REVISED PER ADMIN. ADJUST. GRANTED: 11-02-05
REVISED PER ADMIN. ADJUST. GRANTED: 6-28-17
REVISED PER ADMIN. ADJUST. GRANTED: 7-17-17 as per CUP2017-32 ffh

COMMERCIAL COMMUNITY UNIT PLAN AMENDMENT NO. 1 (FORMERLY C.U.P.,D.P.-10)

WICHITA MALL SHOPPING CENTER

RE: CUP2017-32 – City Administrative Adjustment to the Wichita Mall Shopping Center CUP DP-10 to Parcel 1 to reduce required number of parking spaces in LC Limited Commercial zoned property and reduction of a portion of the required landscape buffer; generally located at the southeast corner of East Harry Street and South Roosevelt Avenue

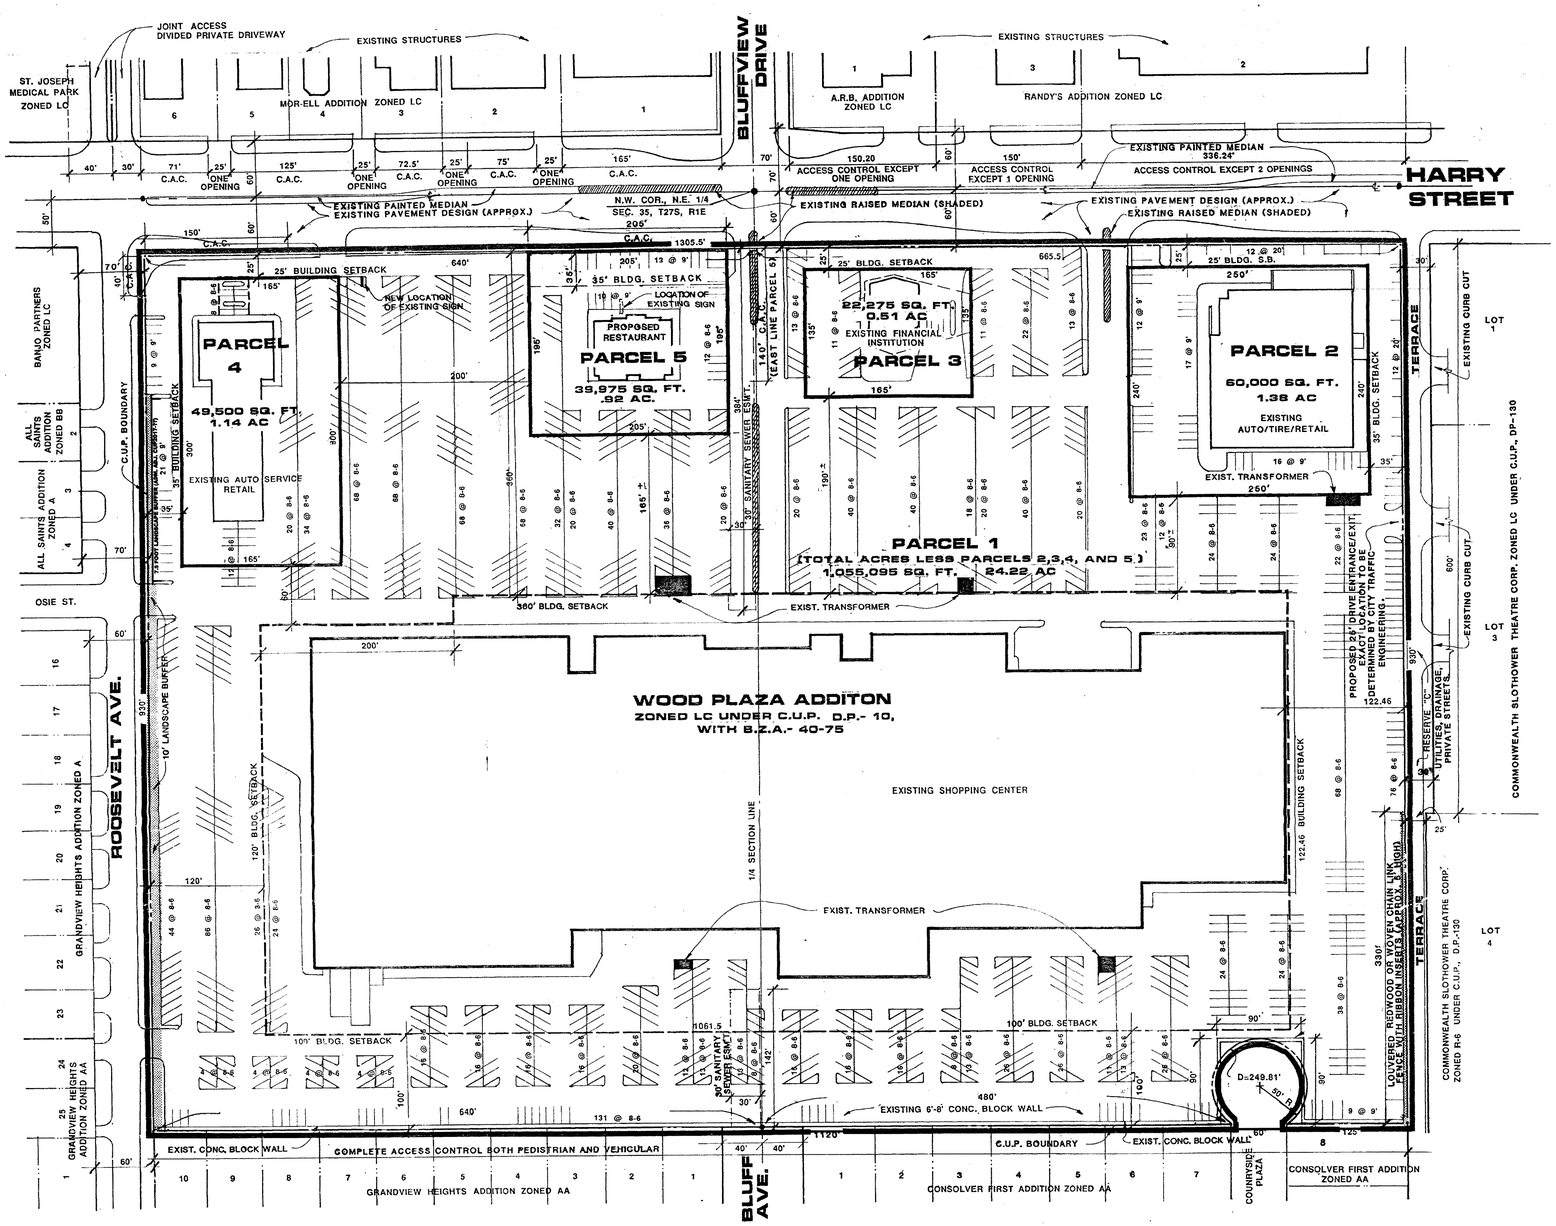
We received and reviewed your request for an Administrative Adjustment to Parcel 1, DP-10, to reduce the required number of parking spaces from 1,863 to 1,587 spaces, a 15% reduction of the Unified Zoning Code (UZC) requirement for the site. Sec. V-I.2.i of the Unified Zoning Code allows an adjustment to reduce the parking requirement for LC zoning by up to 25% when the conditions required by Sec. V-I.6 of the Code are met.

The applicant is also requesting the required 10-foot landscape buffer along South Roosevelt north of the north line of Osie Street, approximately 200 feet, be reduced 25% to 7.5 feet as indicated on the CUP.

On the basis of our review, we find that adjusting the CUP in the manner stated above is consistent with the approved CUP and will not have an adverse effect on the CUP or adjacent properties, nor will it be a substantial deviation of the original plan.

Our signatures below indicate that the CUP shall be adjusted as stated in this letter. This CUP adjustment shall not be deemed to alter any other provisions of the CUP except as expressly stated herein.
